# REPLACEMENT OF TENSIONER AND VIBRATION DAMPER

**TECHNICAL INFO NO. 1098**

Audi, Seat, Škoda, VW

AWT, AWM, ALT, AVJ, AMB, BFB, BEX, BKB, CFMA

Image 1: Vibration damper 55712 (left), tensioner 55496 (right)

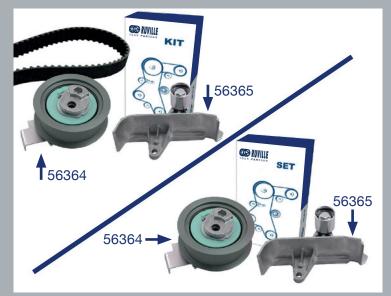
In the vehicles listed above, vibration damper 55712 (Image 1, left) and tensioner 55496 (Image 1, right) have been replaced with Kit 5636471 (Image 2, left) and Set 5636450 (Image 2, right).

The new components differ not only in terms of their appearance but also in terms of their functionality. With the old design, the vibration damper, in addition to the tensioner, took on part of the belt tensioning function.

The new deflecting pulley with holder 56365 only has a deflecting function. The belt tension and damping is carried out by tensioner 56364 only.
